Letter 54

PARKMERCED  
San Francisco, California

Attn: Mr. Bill Wycko Environmental Review Officer  
San Francisco Planning Department  
1650 Mission St. Suite 400 S.F., CA 94103

OWNERSHIP

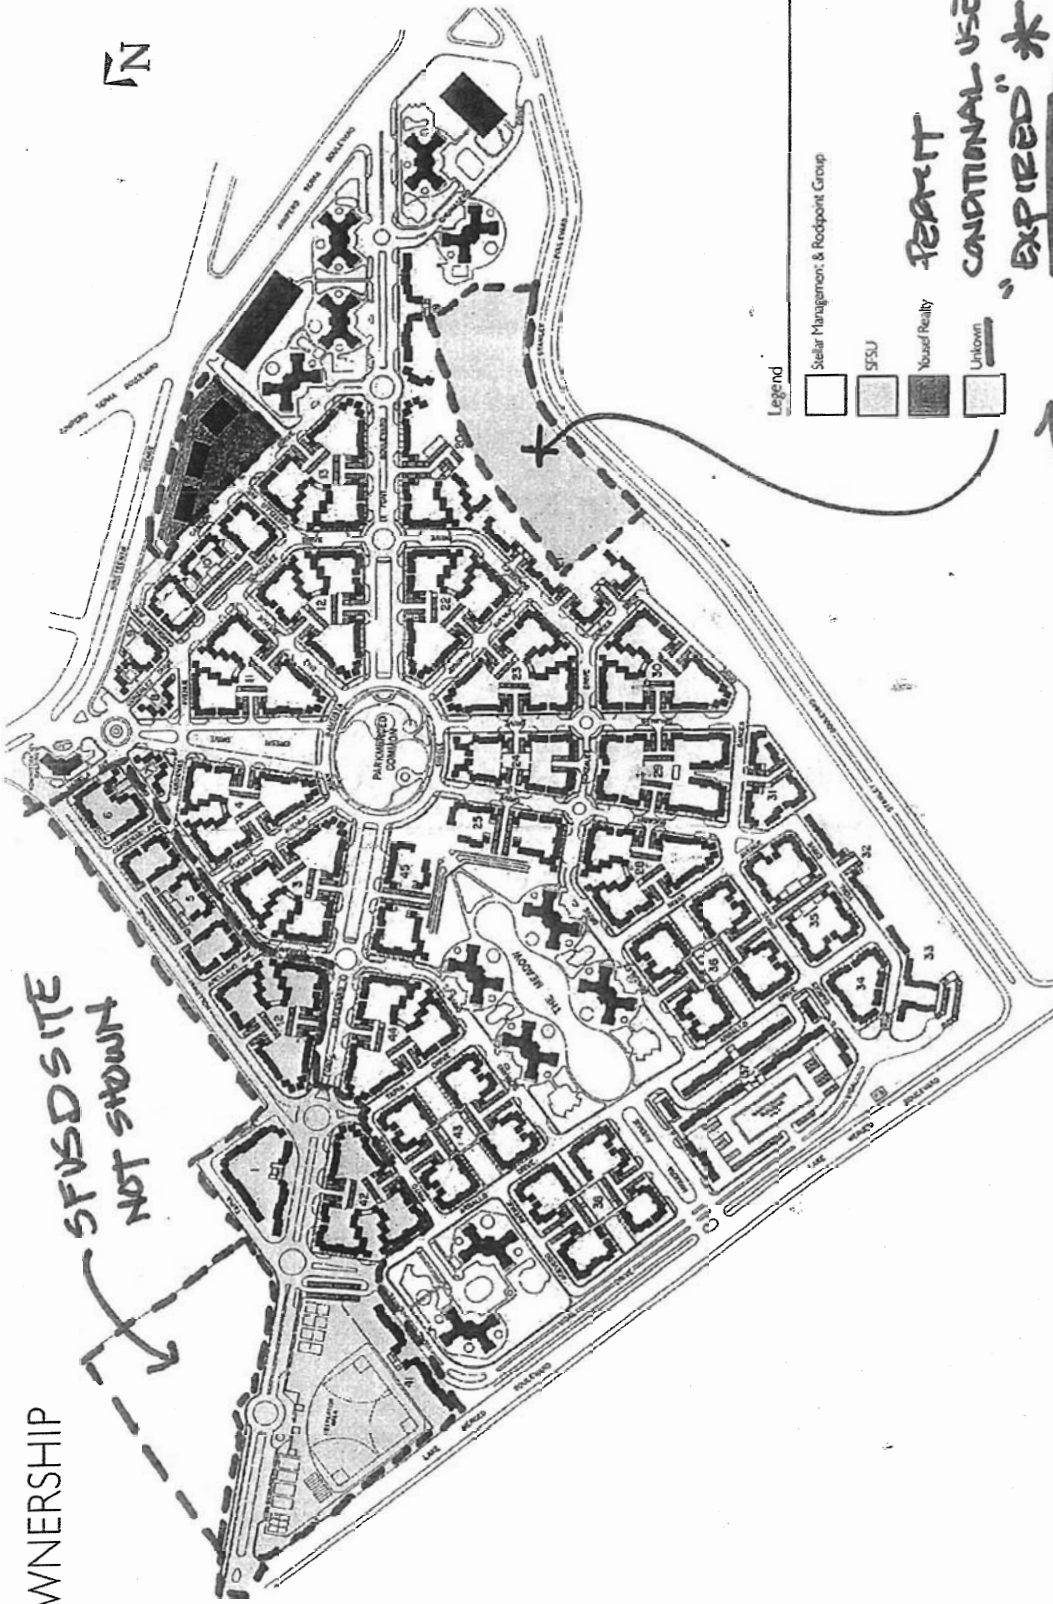
PRIOR OWNER OF PARKMERCED  
RON ZEFF / CARMEL  
PROPERTIES

PEIR - LAND OWNERSHIP  
ERRORS NOT NOTED &  
CORRECTED

P1 RENTING PLOT PLAN

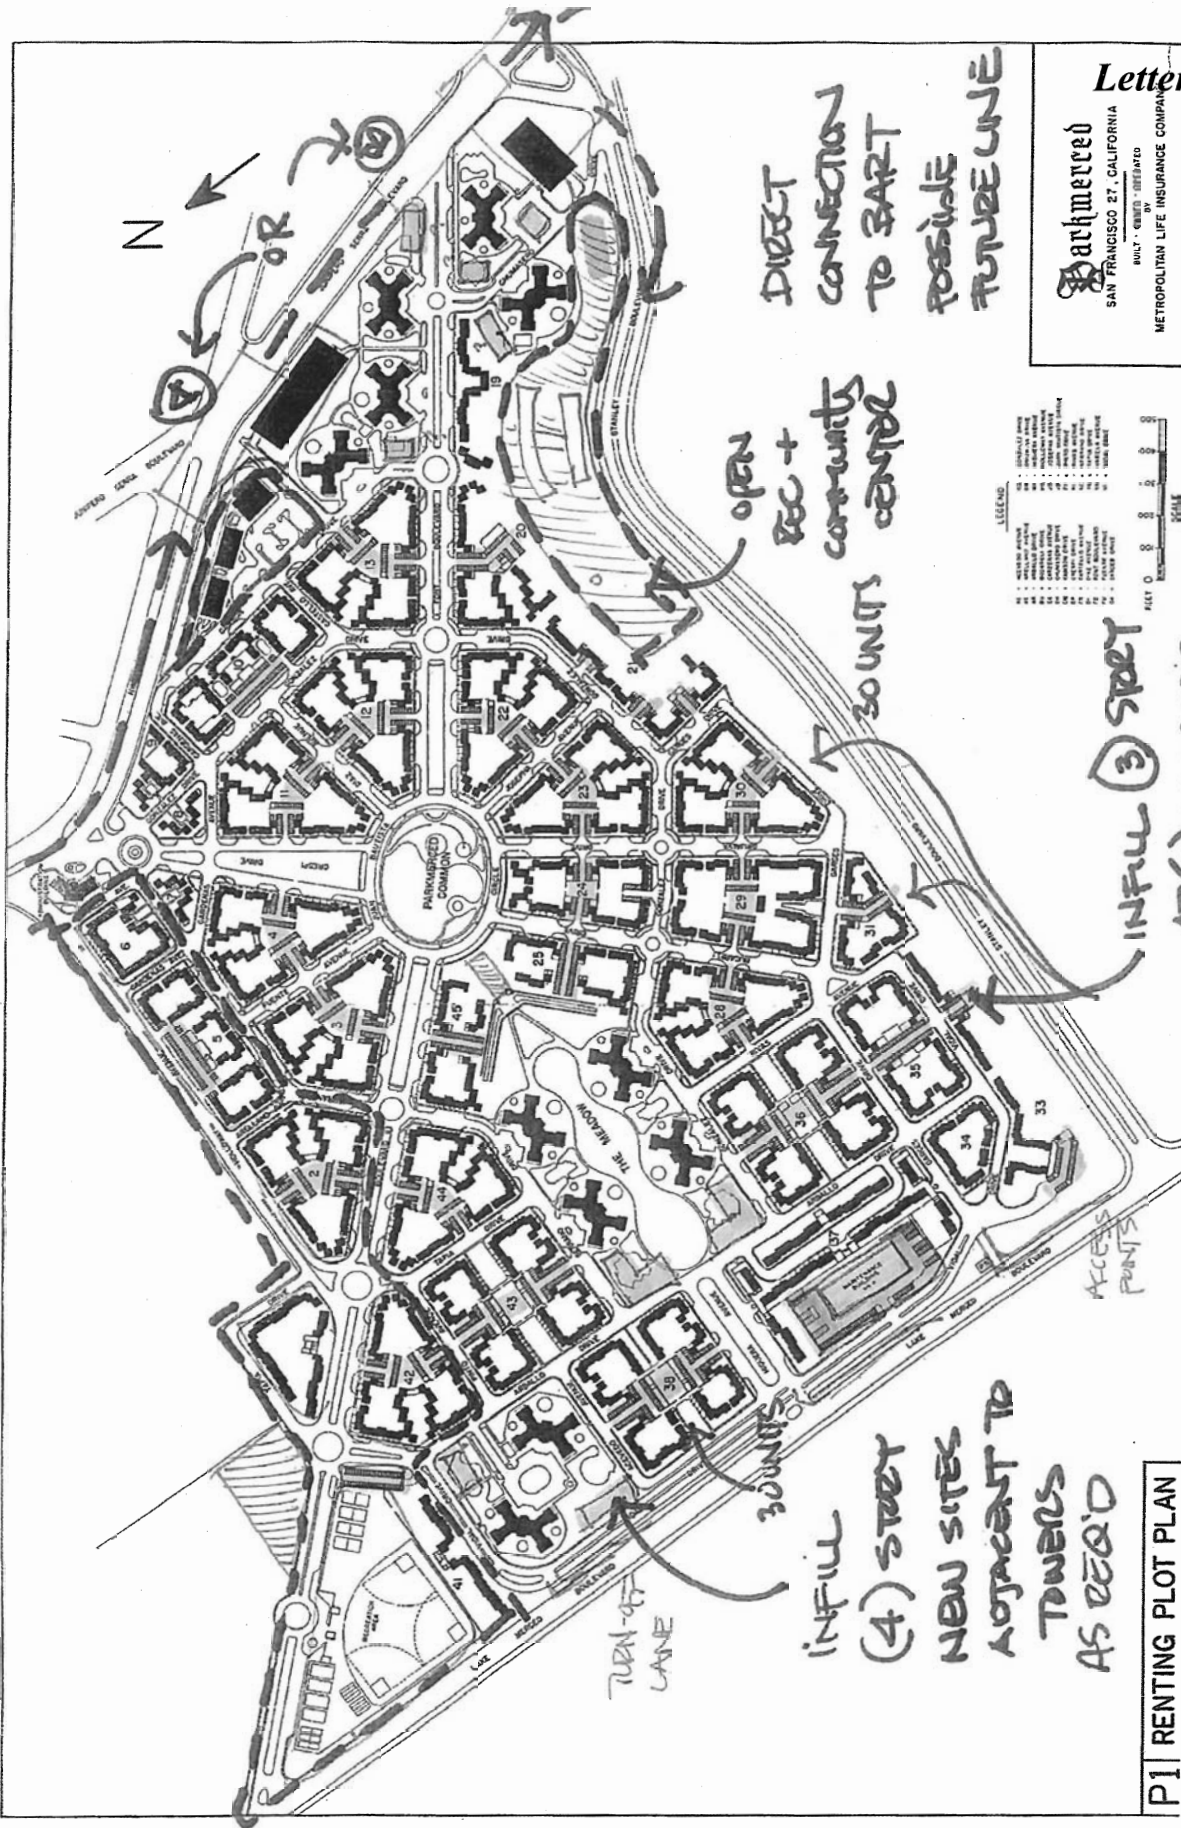
ALTERNATIVE #6 - "LANDSCAPE PRESERVATION"  
ALTERNATIVE - BEST OPTION SIM TO GA

P1 RENTING PLOT PLAN

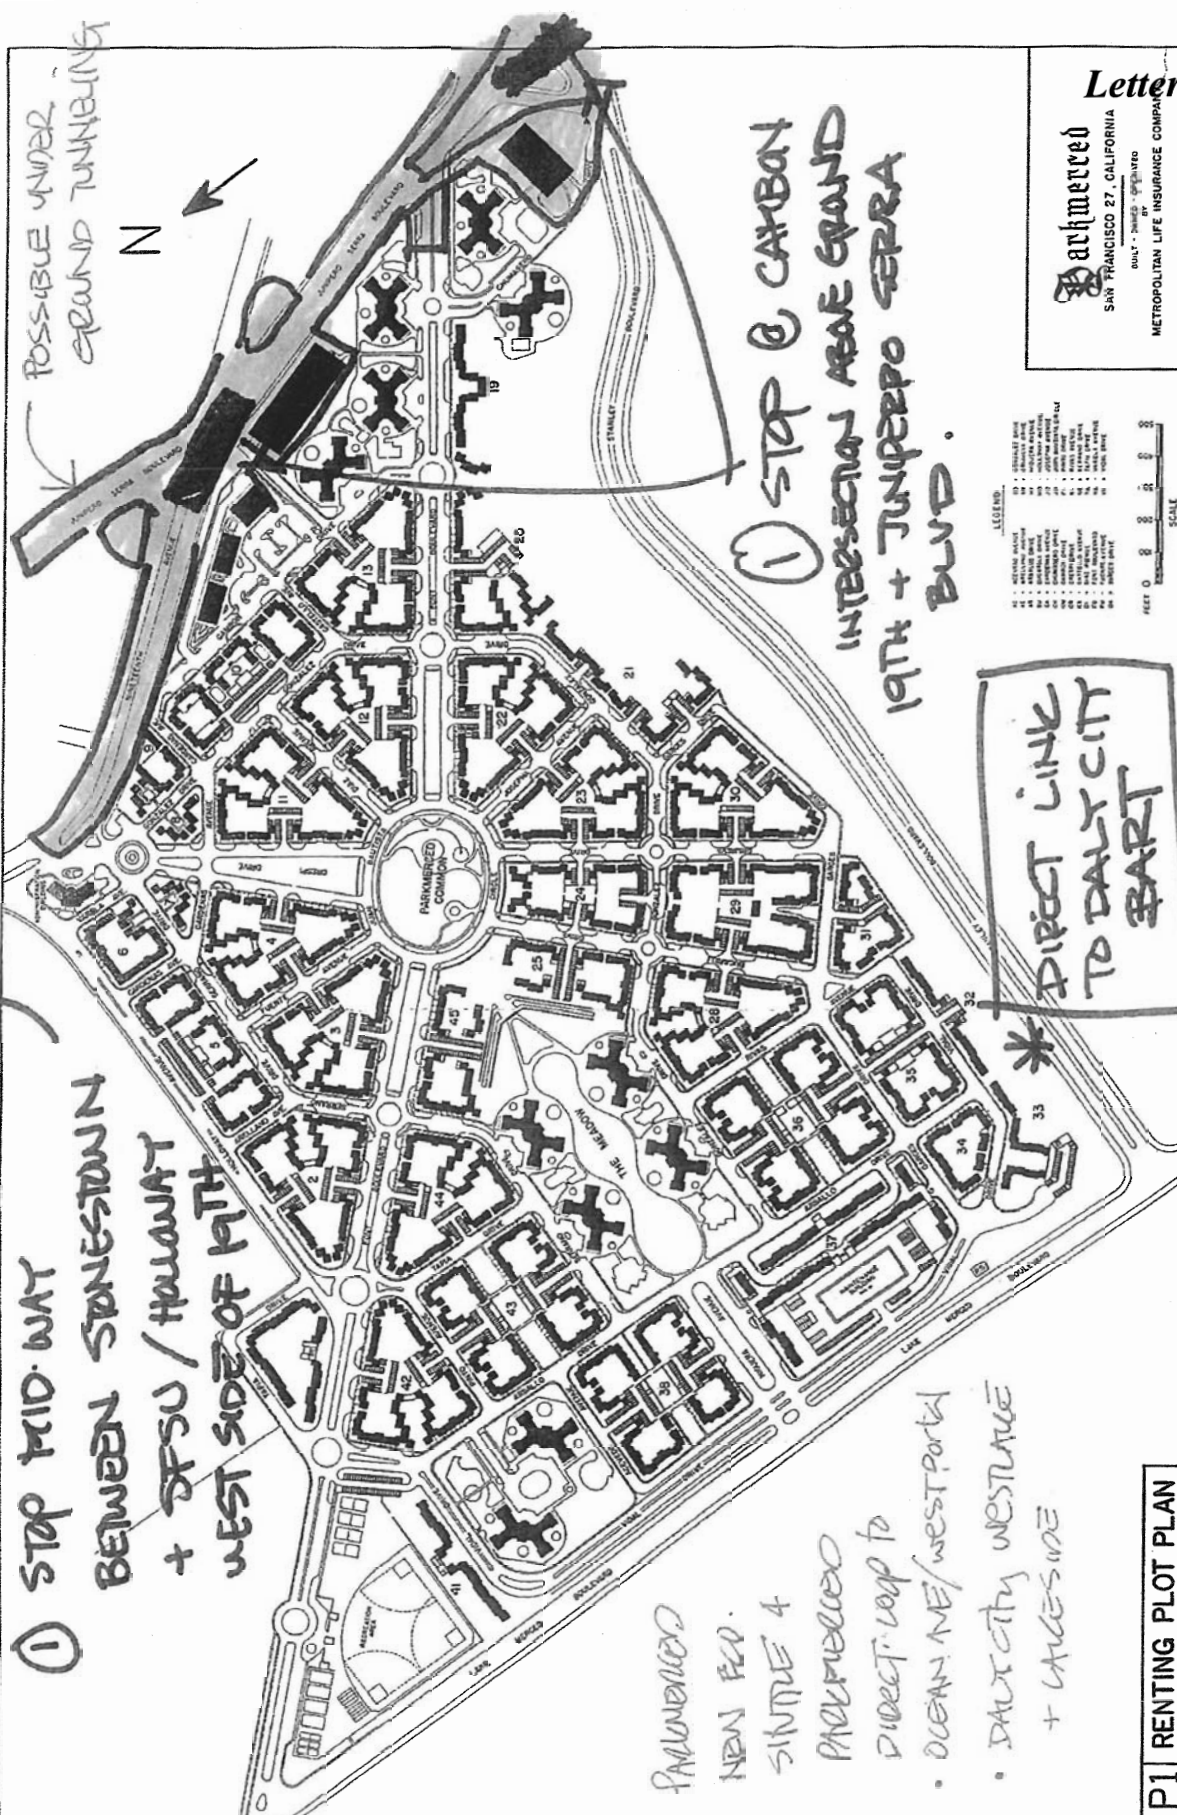
① STOP MID-WAY  
BETWEEN STANESSTOWN  
+ DFSU / HALLWAY  
WEST SIDE OF 19TH

① STOP @ CAMBAY  
INTERSECTION ABOVE GRAND  
19TH + JUNIPERO SERRA  
BLVD.

DIRECT LINK  
TO DAILY CITY  
BART

PARKMEERED  
NEW REP.  
SUTURE 4  
PARKMEERED  
DIRECT-LOP TO  
• OCEAN NE/WESTPORT  
• DAILY CITY WESTPORT  
+ AUGUSTINE

ALTERNATIVE #8 - TRANSPORTATION (NEW TRANSIT LINES) ALTERNATIVE

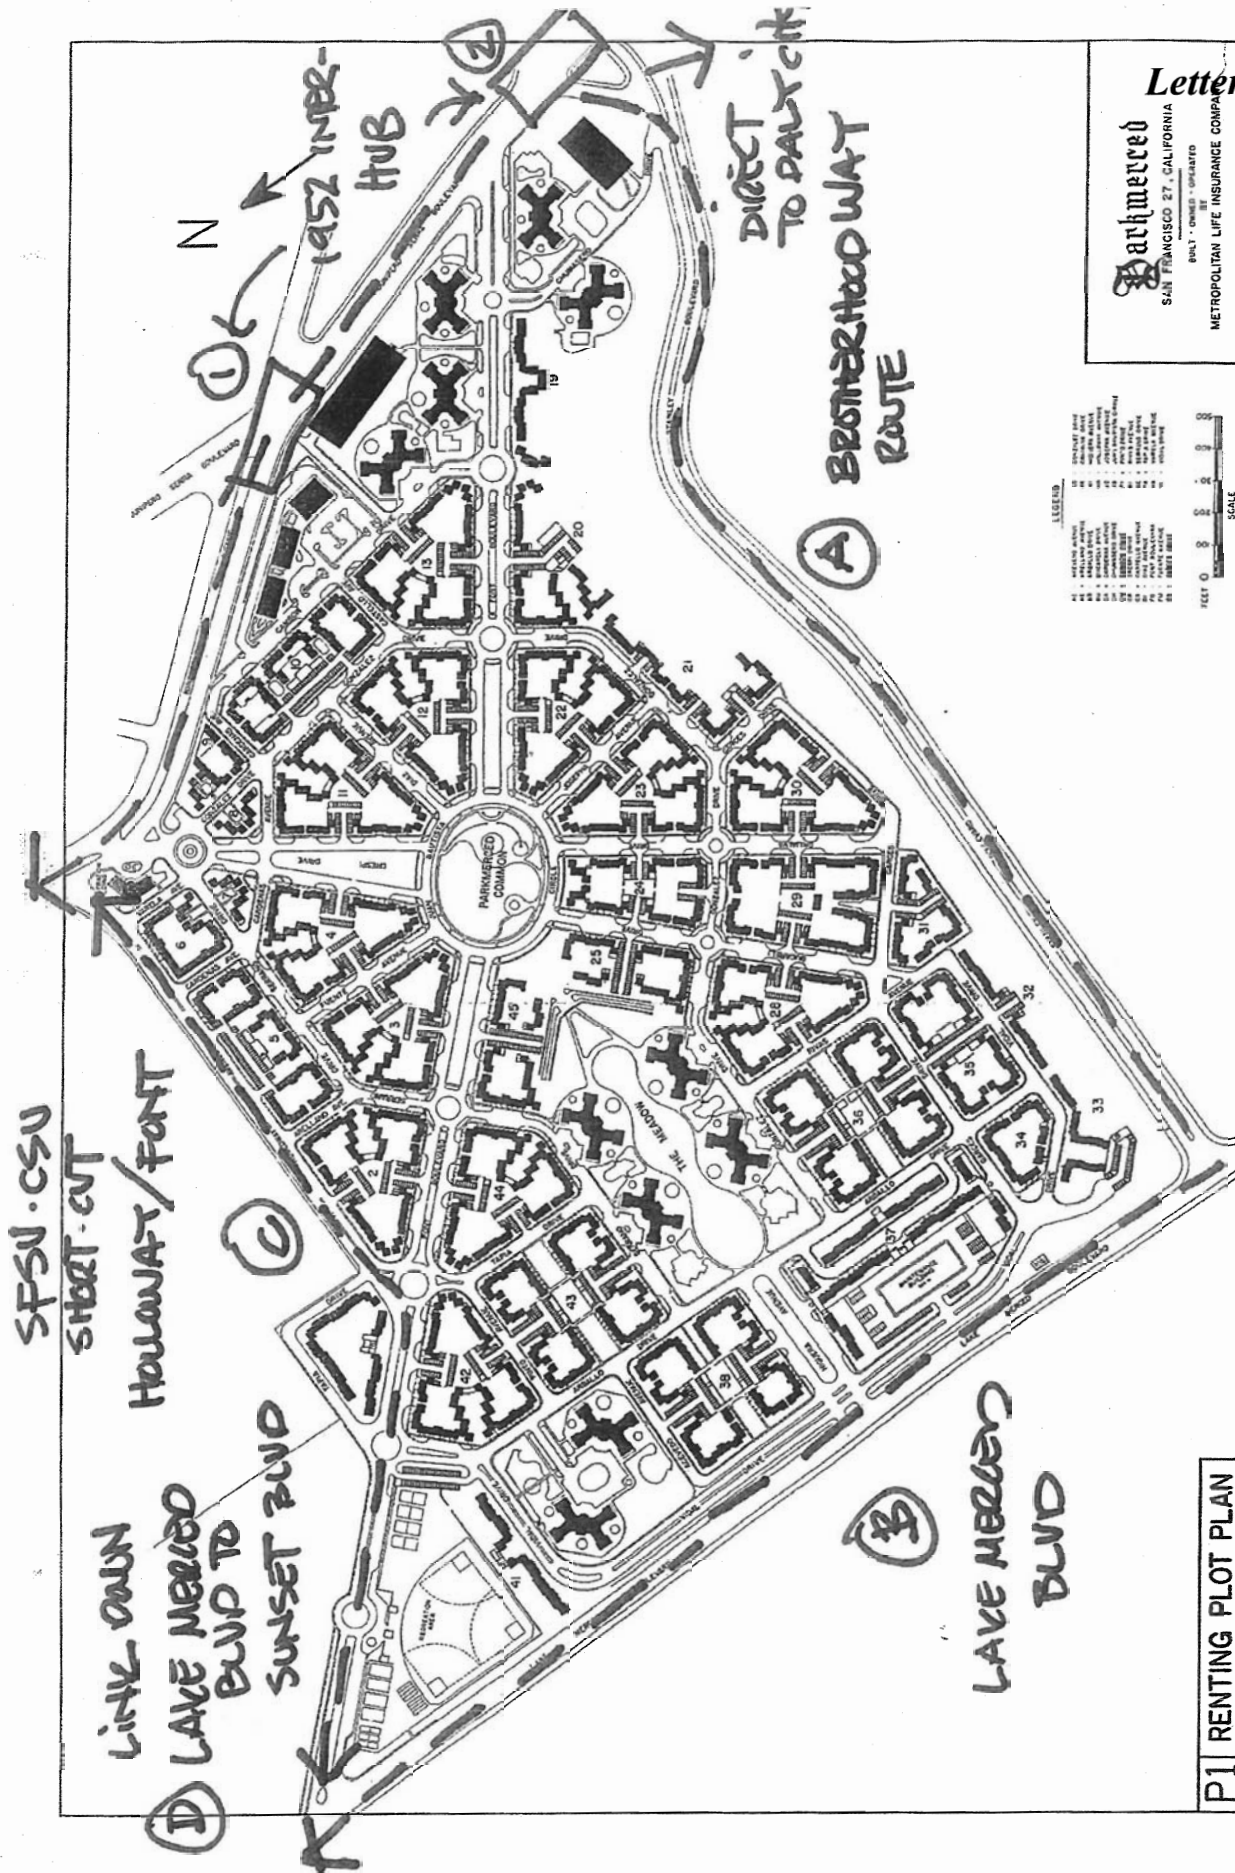
- STONESTOWN
- SFSU - CSU PEIR BORDERS
- WEST PORTAL
- OCEAN AVE

PROPOSED PROJECT WITH DEVELOPMENT ALTERNATIVE

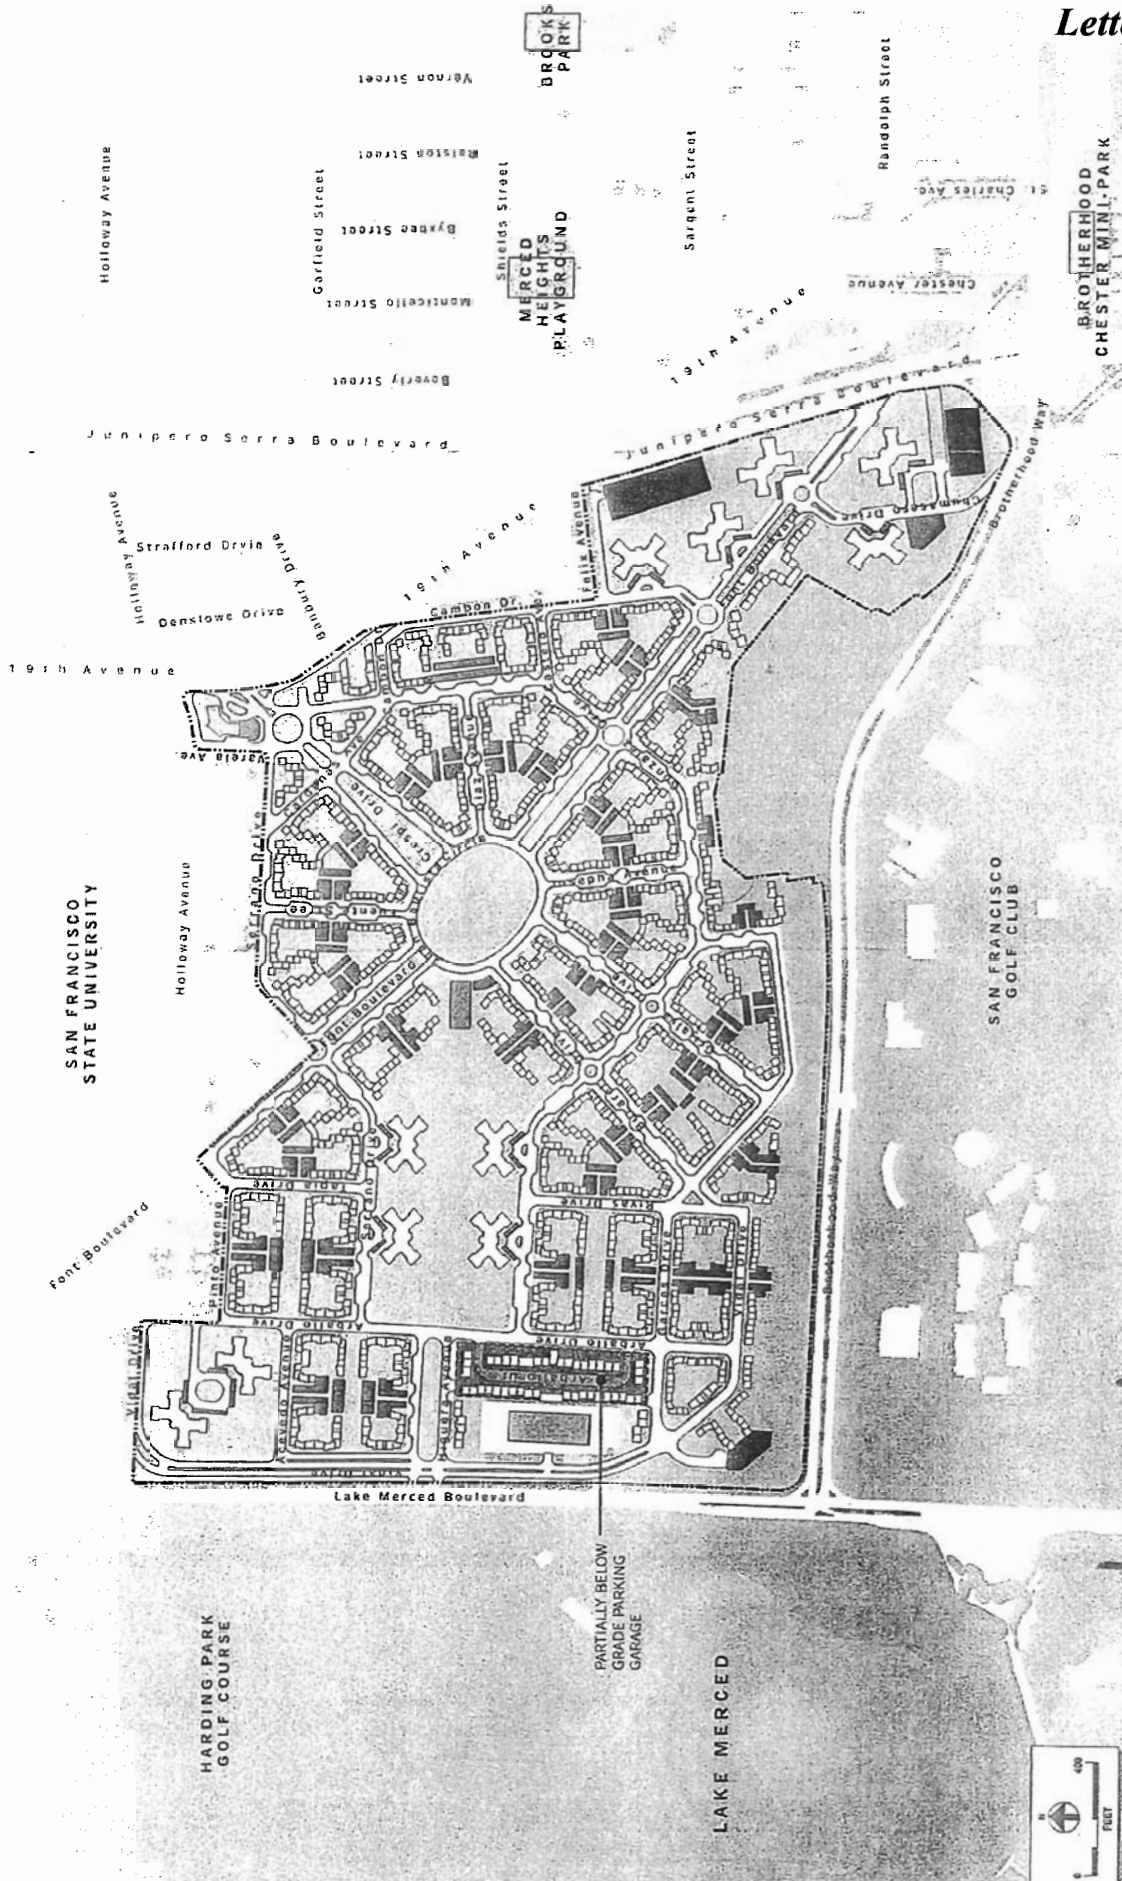
PAGE + TURNBULL OPTION "Ga"  
INFILL OPTION (REJECTED)  
BT ST-PLAN / + PROT SPANOR

DIAGRAM OF (E) PARKING  
SHOWS INFILL POTENTIAL  
CLEARLY.
